Notice of Specification Change Regarding Degree of Protection

Sealed Vibration Sensors/Tilt Sensors・D7E series
< Refer to the " [Details of applicable model] " . >

Effective as of our factory shipment in November, 2023.

Examples of products

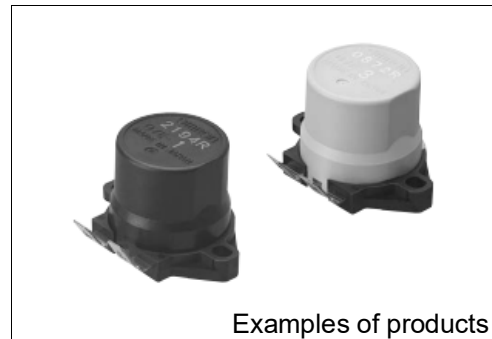
We conducted an IP67 test as a test to confirm the ability of t Degree of Protection of the basic specifications.

●Contents of IP performance in the data sheet
Changes: Notes *2 on "Degree of Protection" in "Basic specifications" of "Performance"

*2 The degree of protection confirms that this product has undergone and passed an IP67 test conducted in OMRON's laboratory under controlled conditions, in accordance with the test methods of the following standards.
IEC 60529 and JIS C0920

Due to the product structure, this inspection of the degree of protection does not guarantee the product's compliance with IP67.

We will change the ability confirmation test of the protection structure of the basic specification to IP65 test.

*2 The degree of protection confirms that this product has undergone and passed an IP65 test conducted in OMRON's laboratory under controlled conditions in OMRON, in accordance with the test methods of the following standards.
IEC 60529 and JIS C0920

Due to the product structure, this inspection of the degree of protection does not guarantee the product's compliance with IP65.
